Duxbury Nuclear Advisory Committee  
Town Hall, Duxbury, Massachusetts 02332  
September 29, 1992

**RE: Emergency Planning- Protective Clothing & Breathing Apparatus for Harbormaster + Staff**

#### **Emergency Planning--Radiological**

## Plume Exposure Pathway

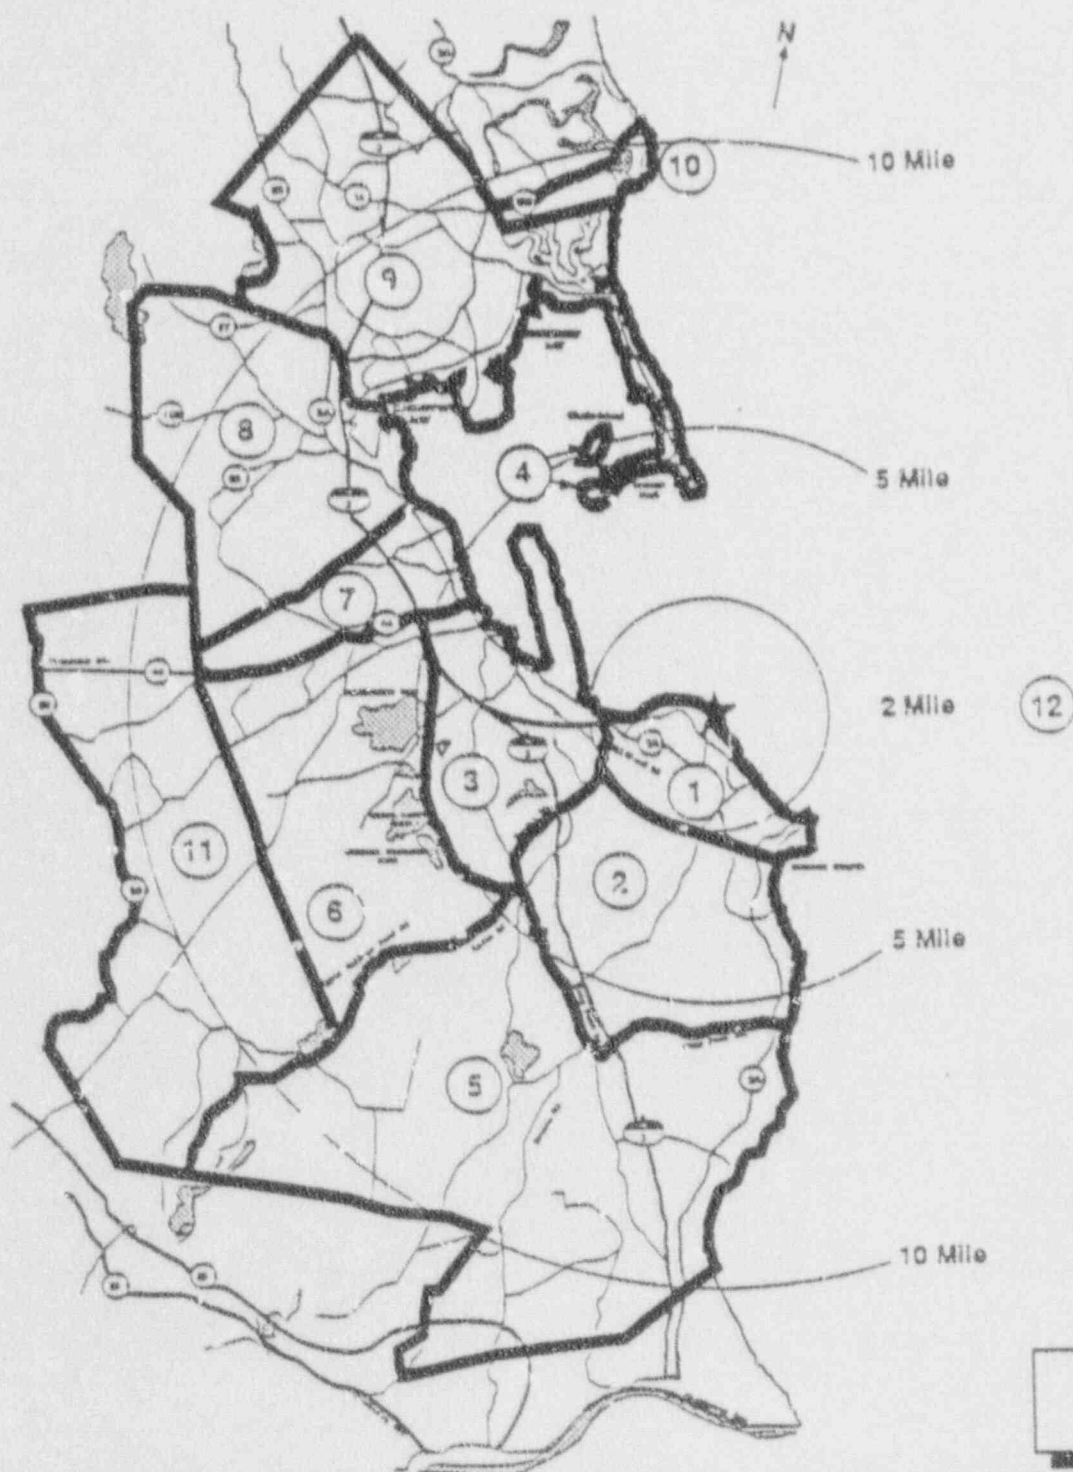
On the other hand, the Harbormaster appeared before our committee in October, 1991 and said without protective equipment neither he nor his assistants could safely perform their functions. He pointed out that these functions included notification of boaters in Duxbury and Plymouth Bays (which, as shown on the enclosed map are directly in front of the Pilgrim Plant), residents of Clarks Island (5 miles from the plant), and beachgoers (5 to 7 miles from the plant). He also noted that these tasks are to be largely performed in an open boat. Further, his situation was somewhat unique; he and his personnel were the only emergency workers required to head south, towards the Pilgrim Nuclear Power Plant, while at the same time, the rest of the population was being instructed to evacuate in precisely the opposite direction.

the time, is the "time delay" between release and when "this gaseous plume reaches Duxbury" long enough for the unprotected Harbormaster to do his job? It is not unusual for the area to experience 20 mile an hour winds in a non-storm weather pattern. Clark's Island, a responsibility of the Duxbury Harbormaster, is 5 miles from the Pilgrim Nuclear Power Plant.
